Model: Adonis-C4.5			Date	te: 08-Nov-06		No.: RB296001a
RTB Reissue The items in bol	d italics have been add	ed.				
Subject: Firmware Release Note: Engine				Prepared by: K.Takagi		
From: 1st Tech. S	Support Sec. Service Suppor	rt Dept.				
Classification:	☐ Troubleshooting	☐ Part info	rmati	ion	Action	required
		☐ Electrica	al		Service	ce manual revision
	☐ Paper path	☐ Transmi	t/rece	eive	Retrof	fit information

This RTB has been issued to announce the firmware release information for the **Engine**.

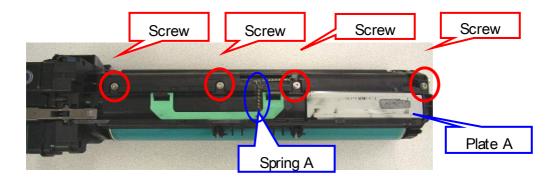
1. Remove 4 screws

2. Slide the developer tank about 5mm then remove the stopper.

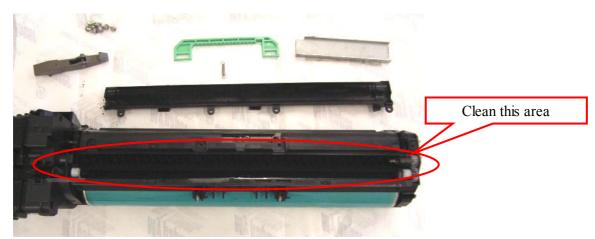
- 3. Remove the Plate A which is fixed by tape
- 4. Remove the Spring A
- 5. Remove 4 screws

6. Remove the upper cover, then clean out the recycled toner using a vacuum cleaner.

Touch Panel Replacement Procedure

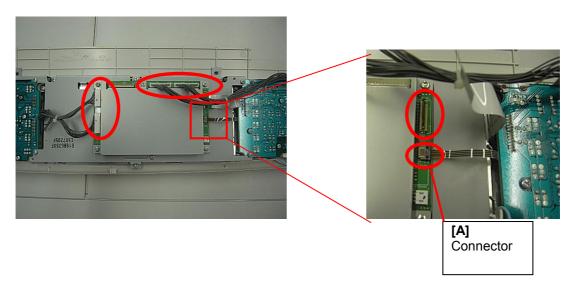
1. Remove the operation panel (screw x 2, harness x 1).

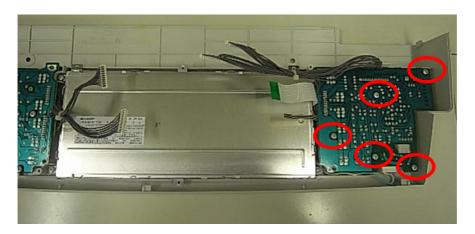
3. Remove the operation panel bracket (screw x 8).

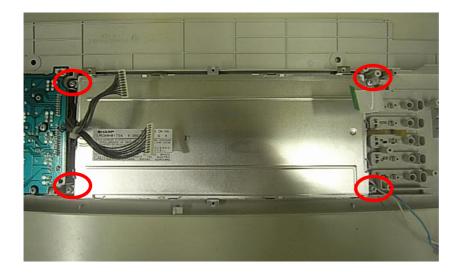
4. Remove the right board (screw x 5) and then remove the connector.

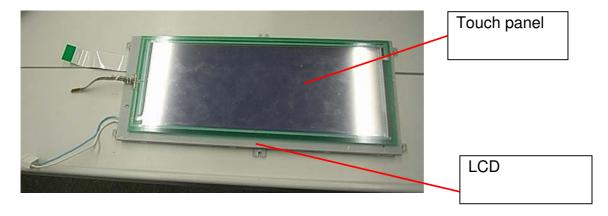
5. Remove the LCD and the touch panel from the operation panel (screw x 4)

6. Remove the touch panel from the LCD.

7. Attach the new touch panel (P/N **H3106173**) to the LCD. **Important:** Only replace the touch panel. Do not replace the LCD.

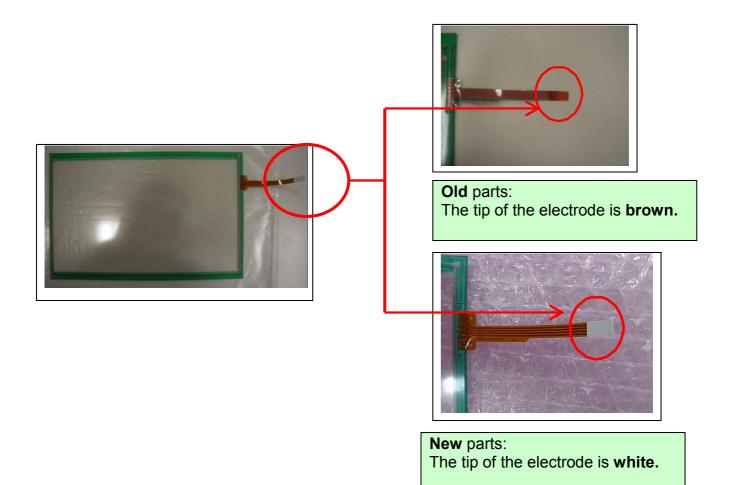
Do not use items [2] to [9] on the Self-Diagnostic Menu. These items are for design use only.

- 1. Press [Clear mode], press [1] [9] [9] [3], press [Clear] 5 times to open the Self-Diagnostics menu.
- 2. On the touch screen press "Touch Screen Adjust" (or press o).
- 3. Use a pointed (not sharp) tool to press the upper left mark.
- 4. Press the lower right mark when "" shows.
- 5. Touch a few spots on the touch panel to make sure that the marker "+" shows exactly where the screen is touched.
- 6. Press Cancel. Then start from Step 2 again if the "+" mark does not show where the screen is touched.
- 7. Press [#] OK on the screen (or press #) when you are finished.
- 8. Touch [#] Exit on the screen to close the Self-Diagnostic menu. Save the calibration settings.

II. Cleaning the development roller surface

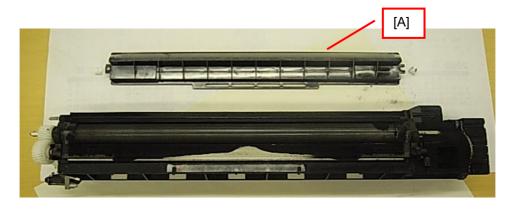
- 1. Remove the development unit.
- 2. Remove the upper development cover [A] (clip x 2).

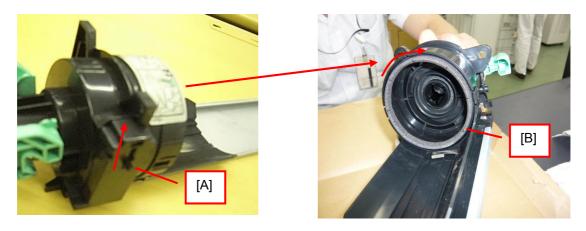
- 1. Remove the toner supply unit.
- 2. Lift up the shutter [A], and then turn the inner plastic parts [B] in the direction of the arrow. Continue turning the parts until you have removed all the toner from the unit.
